PITT STREET SOUTH
OVER STATION
DEVELOPMENT

SUBMISSIONS REPORT

Figure 8 – Three contemplated construction scenarios in relation to construction of the integrated station development

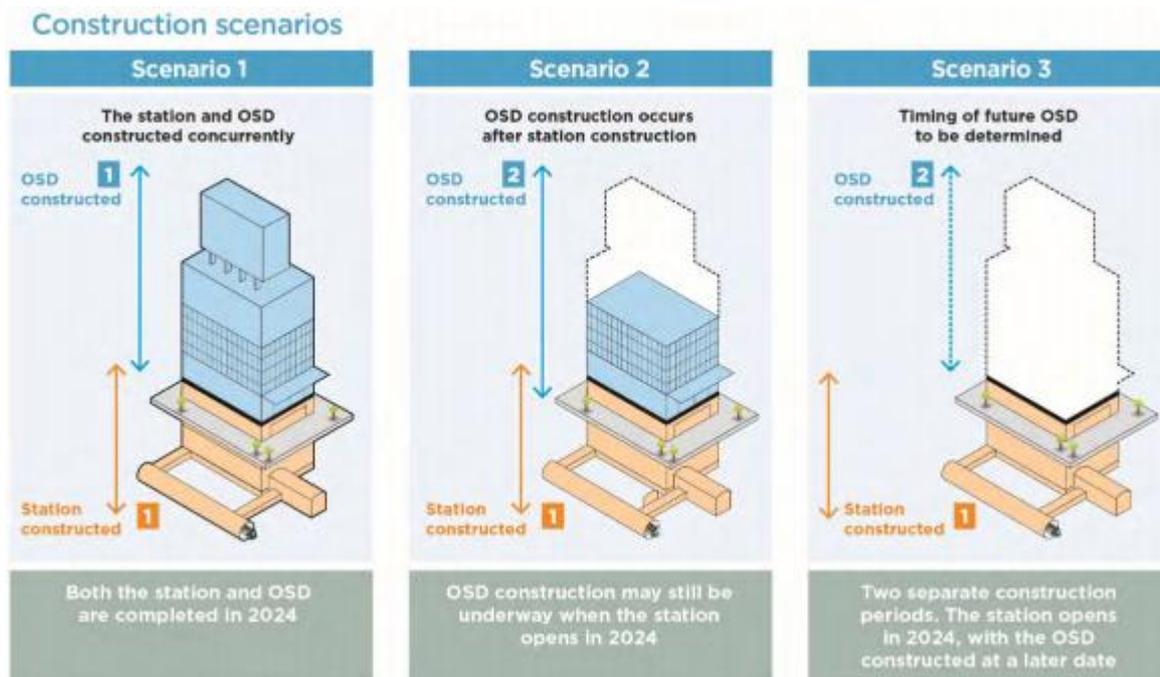
Of the above, Council's issue pertains to Scenarios 2 and 3. Council asserts that by contemplating these scenarios, Sydney Metro is confirming that there would be an adequate degree of flexibility in the program to allow for the undertaking of a design competition in accordance with the *City of Sydney Competitive Design Policy*.

This is not the case. It is stated throughout the EIS and Construction Management Statement that “*Scenario 1 represents Sydney Metro’s preferred option as it would provide for completion of the full integrated station development and therefore the optimum public benefit at the site at the earliest date possible (i.e. on or near 2024 when the station is operational)*”. Additionally, one of the key objectives of this concept SSD Application is to “*provide the opportunity to deliver the OSD as early as possible with the aim of opening concurrently or shortly following completion of the Pitt Street Metro Station*”.

It is Sydney Metro’s strong preference for Scenario 1 to be pursued, rather than Scenario 2 or Scenario 3. Scenario 1 is preferred because of the unique timing constraints of the Sydney Metro project, and to ensure the delivery of optimum public benefits. In the case of Scenario 1, the full scope of the Sydney Metro project integrated station development would be delivered concurrently, which would provide passengers with a world class metro experience which is not inhibited by construction of the OSD.

The above consideration of Scenarios 2 and 3 by Sydney Metro is necessary from an impact analysis perspective. Sydney Metro notes Scenario 1 as the preferred option, but has considered alternate scenarios to ensure that, in the event the OSD is delayed, a framework would continue to exist to ensure that no adverse impacts arise from the delayed construction. This is an appropriate response, given that external impacts outside of Sydney Metro’s control could inhibit the ability for Scenario 1 to be achieved.
